DATE: January 4, 2024
TO: Planning Commission Members
FROM: Tom Schauer, Senior Planner
SUBJECT: Additional Information for Record - Dunn Place PDA 1-23, S 1-23, TML 5-23

This memo provides additional information for the January 4, 2024 public hearing for Dockets PDA 1-23, S 1-23, and TML 5-23 for Dunn Place. This includes written public testimony received by the Planning Department after the December 28, 2023 meeting material packet.

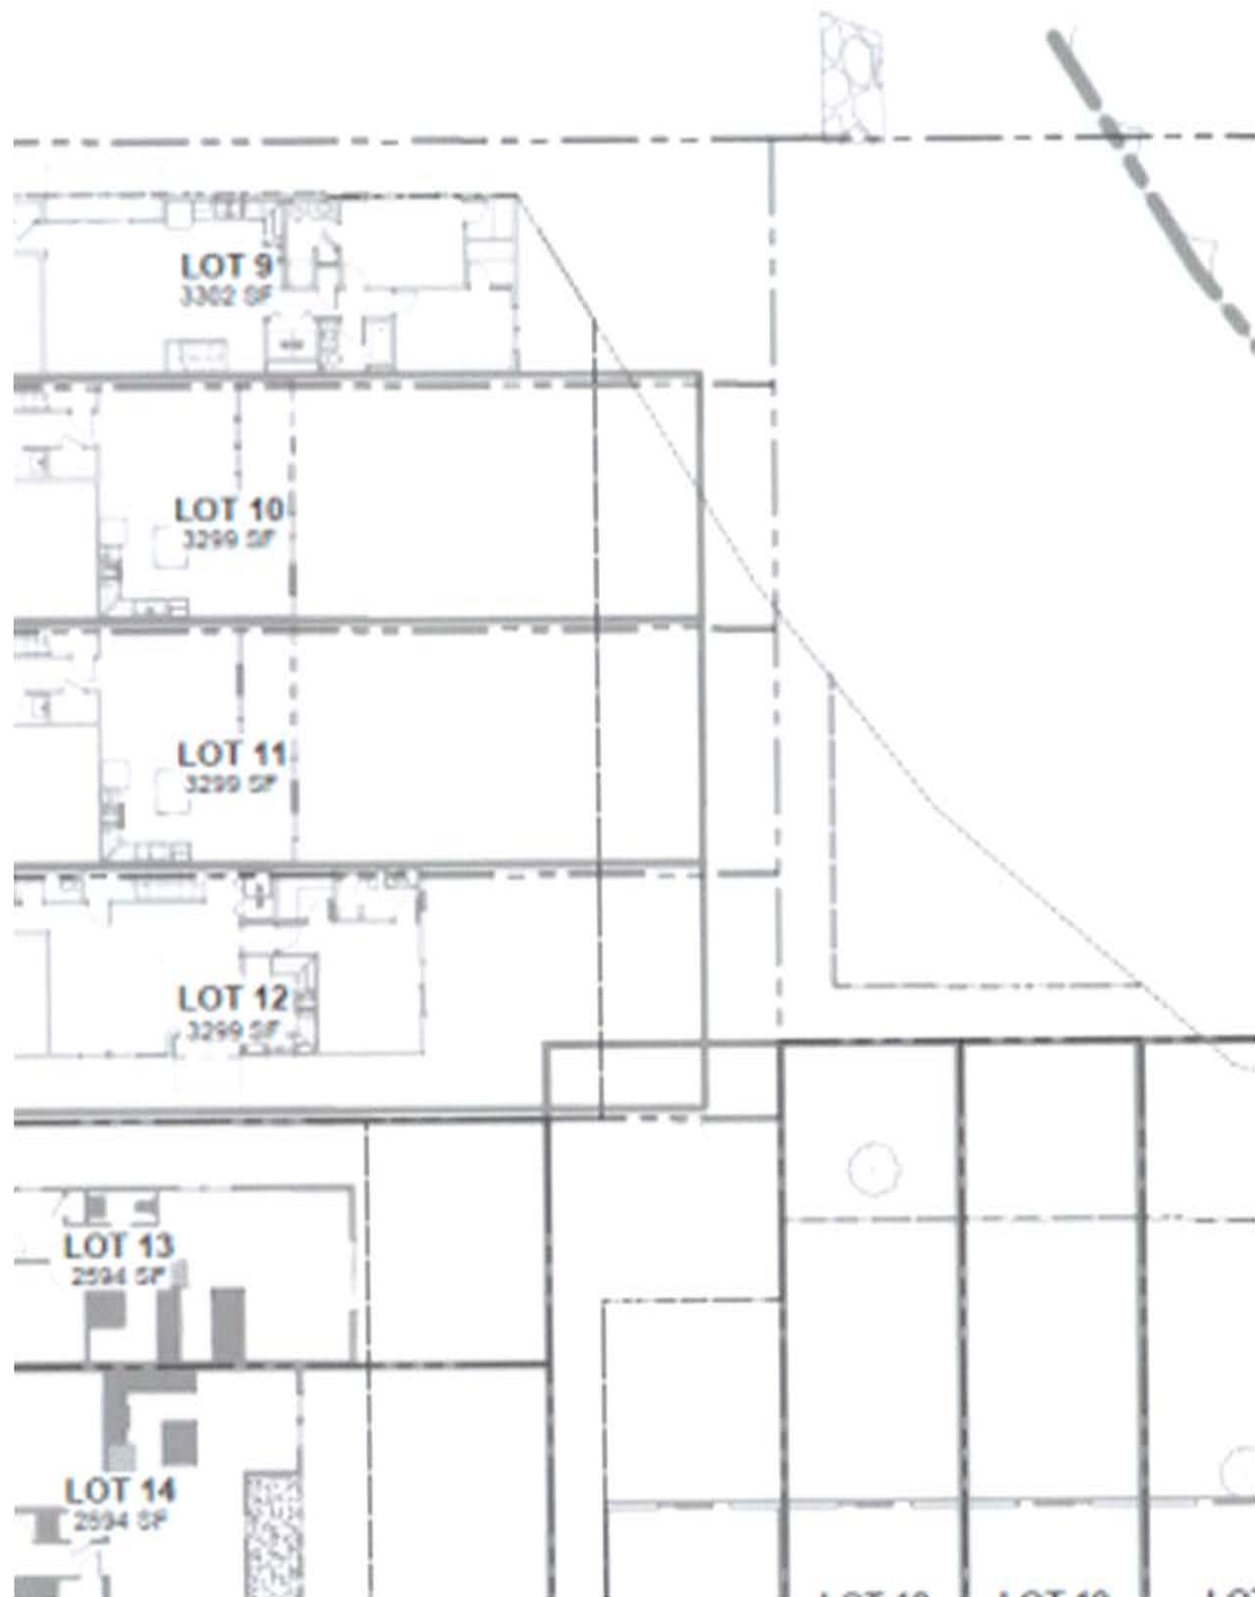
301 Dunn Place, location of continuous bank erosion, is where overflow will enter the river. The trees have slid nearly 100 feet down the bank.

Chalmers Court: This was once a nice lot, neighbors kept it mowed and children played ball on it. Now it slopes precipitously to the river.

This is where storm water runoff ends up when the system exceeds capacity. The documentation submitted by the developer states that *“to the extent practical, stormwater from the roof and street areas be retained in a lined facility, with a pipe overflow on to the street curb, or stormwater main pipe (if one exists).”* The lined facility itself is depicted as being at least partially inside of the setback area. When this system is overcapacity with the City requiring a zero impact on its storm drain, the water ends up on the street, and onto the bank at 265, 276, and 301 Dunn Place as well as Chalmers Court: the properties most at risk from innundation of this type. But as the developer told us at the public meeting in 2022: **“Erosion on your property is not our problem!”**
